**SCOTTISH HYDRO ELECTRIC TRANSMISSION (SHE
TRANSMISSION): CAITHNESS – MORAY TRANSMISSION
REINFORCEMENT**

Strategic Wider Works Project Assessment Report - Final

Ofgem

Report No: Final
Document No: 1
Date: 22 October 2014

Figure 7: Existing proposed route showing extra 77 km of subsea circuit for LT21

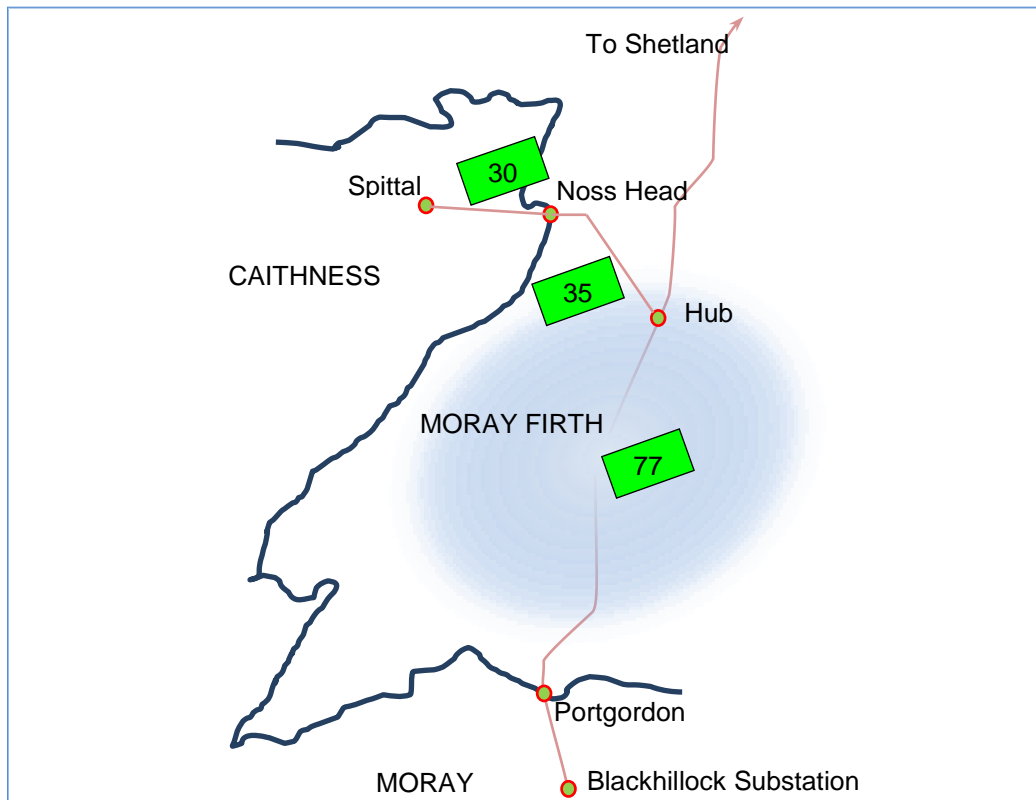
SHE Transmission is planning to build a point-to-point HVDC subsea transmission link between Caithness (Spittal) and Moray (Blackhillock). The intention had previously been to take a mixed overland / subsea route from Spittal, running eastwards via Noss Head, to an offshore hub, where the link would connect into a north-south HVDC connector from Shetland to Blackhillock Substation via landfall at Portgordon (Figure 7). The total length of this extra link would be approximately 65 km ^[**], given the existence of the Shetland – Moray connector.

However, these plans have been superseded by the point-to-point HVDC link between Caithness-Moray because the Shetland – Moray connector will not be available at the time the transmission capacity is required to export power from new generation on the mainland. As Figure 7 shows, an extra 77 km or so of HVDC subsea cable is thus required to complete this Caithness – Moray project over and above the originally anticipated 65 km – a total of around 142 km.

Figure 8: LT21 Eastern and Western Alternative Routes

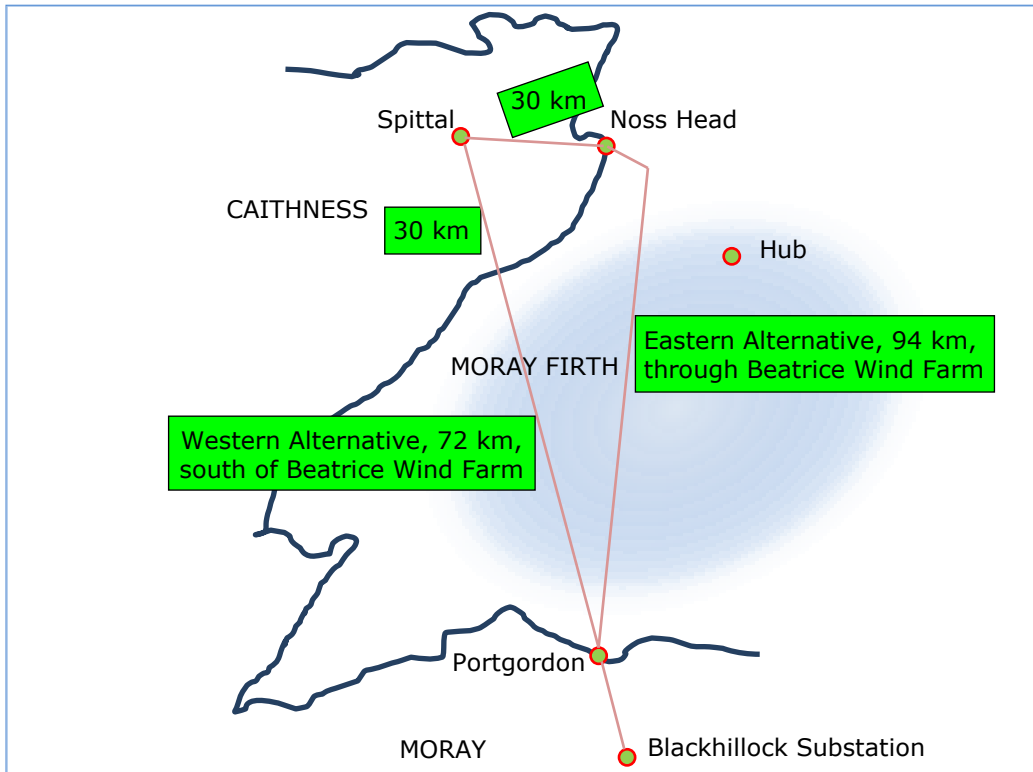
This being the case, the HVDC hub is no longer a relevant consideration for the subsea cable route for the Caithness – Moray project itself. Therefore two alternative routes offer themselves for consideration by the project optioneering process, both significantly shorter than the overall 142 km presently proposed by SHE Transmission. They are designated here the Eastern Alternative, which still runs via Noss Head, and the Western Alternative, which would require a new landfall to be found further to the south-west. These two alternatives are shown in Figure 8.

The Eastern Alternative comprises the same overland cable route between Spittal and Noss Head as before plus a more direct subsea route from Noss Head to Portgordon. It would have a total route length of around 120 km to 125 km, but would pass through the proposed Beatrice offshore windfarm area.

The Western Alternative would try to take a direct line from Spittal to Portgordon. In this case the overland route might also be in the region of 30 km long, whilst the length of the submarine portion would lie between 70 km and 75 km. In this case the route would pass, with little or no deviation, to the south of the Beatrice wind farm. The alternative route lengths are compared in Table 5:

Optioneering for the LT21 Caithness – Moray HVDC Reinforcement following the decision to not employ an offshore HVDC hub does not appear to have considered all the routeing options in detail.

The Western Alternative as described in Section 3.3.1.1 may offer a cost saving of up to [•], particularly if the development plans for a transmission link to Shetland are significantly modified, or turn out to be not needed. We acknowledge, however, that pursuing a shorter route now could delay the completion of the C-M link and thus weaken its overall net benefits, particularly if increased constraint costs are a consequence.

Potentially there is an apparent CAPEX inefficiency associated with the cable routeing plans, and this sum has been included in our CAPEX allowance reduction recommendation. However, given the magnitude of this single item, and the current planning uncertainty, it has been retained as a separate item in the summary tables and recommendation.

Figure 9: Figure 4.1 of the Spittal to Hub Route Selection Report

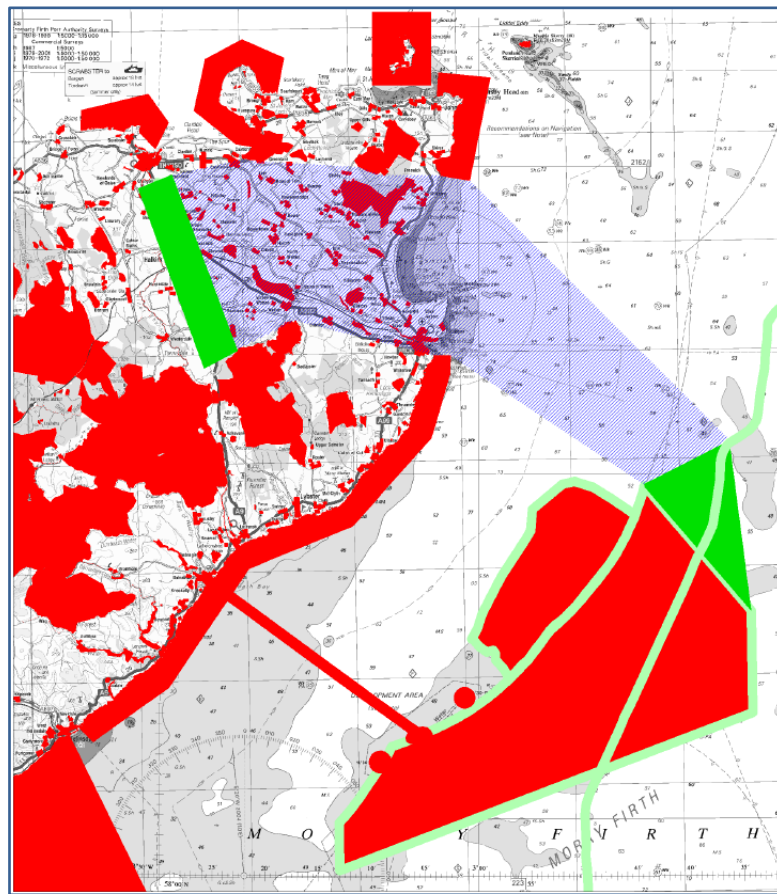
The viability of these two alternative routes would be subject to the constraints that lie along their paths. Some key constraints determined by SHE Transmission are shown in Figure 4.1 of their “Spittal to Hub Route Selection Report”, shown next in Figure 9, which depicts part of the Moray Firth and surrounding terrain. It indicates:

Figure 9 indicates that the obstacles to cable-laying include environmentally sensitive areas inland and along the coastline, existing oil wells, existing submarine power lines, and the area of the proposed Beatrice offshore wind farm. However, whilst we note the barriers to cable-laying indicated on this map, it is evident from the same diagram that these barriers do not, in themselves, comprise immovable obstacles to cable routeing, since some of the largest barriers (the environmentally sensitive coastal region around Noss head and the Round 3 wind farm) are being crossed by the search corridors for the Spittal – Hub HVDC link and the Shetland – Portgordon connector respectively.

A recent SQ response (CM_LT21_047 to 052 Response.pdf) indicated that some other routes had been considered, however we have been unable to find a detailed description of these in the LT21 submission pack. Certainly the shorter “Western” overland route from Spittal along the A9 corridor to the A9/A99 road junction near the coast at Latheron does not appear to have been considered in depth. (This impression is confirmed by the SHE Transmission paper “Comments on HVDC cable routeing.pdf” and emailed to Ofgem on 16th Sep14, which states in its penultimate paragraph that this option has not been considered.) Some of the constraints and barriers on the Latheron route were mentioned in the SQ response; however there was no apparent consideration of the costs to

overcome the barriers (for example the power cable to, and the pipeline from, the expiring Beatrice oil field). Equally, there was no acknowledgement in the SQ response or the HVDC cable routeing paper that the environmental constraints might be overcome, yet the existing proposal already apparently breaches an environmentally sensitive area at Noss Head. Having said this, we recognise that much exploratory work and route surveying has already been carried out for the proposed routeing, so the assessment of any alternative route would need to offset the costs of both the extra surveys and any project delays against the anticipated cost savings due to a shorter route.

Figure 27: Enough Monte Carlo iterations?

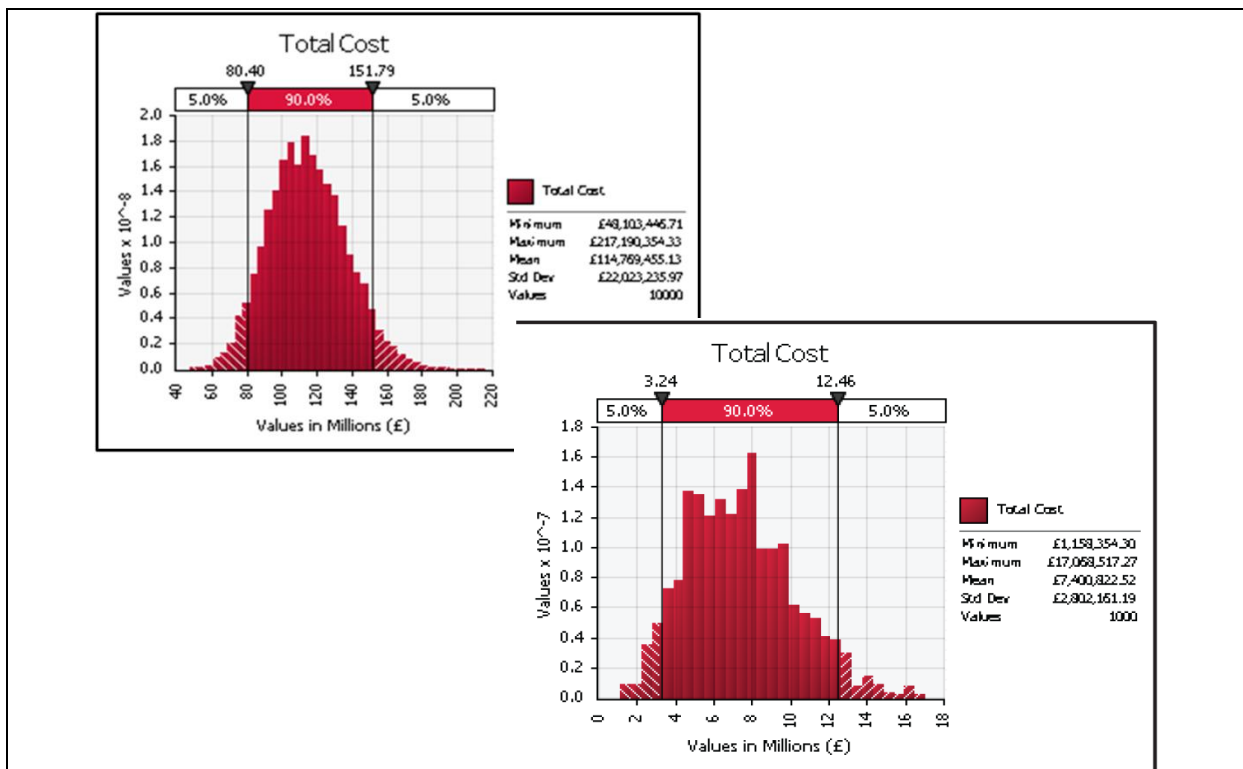
- The MC models for some of the projects look as if inadequate runs have been made to reliably fix the P50 value. For example, whilst the left hand histogram in Figure 27 below (relating to LT21, HVDC) shows a reasonable convergence towards mean and median values, the right hand histogram in the same Figure (relating to LT41, Blackhillock S/S) is much less conclusive. The LT21 and LT41 histograms were the outputs of a 10,000 iteration run and a 1,000 iteration run, respectively. The latter histogram’s median could easily be higher than is justified by the risks being modelled, thus over-estimating the expected impact by, perhaps, 5 – 10%.
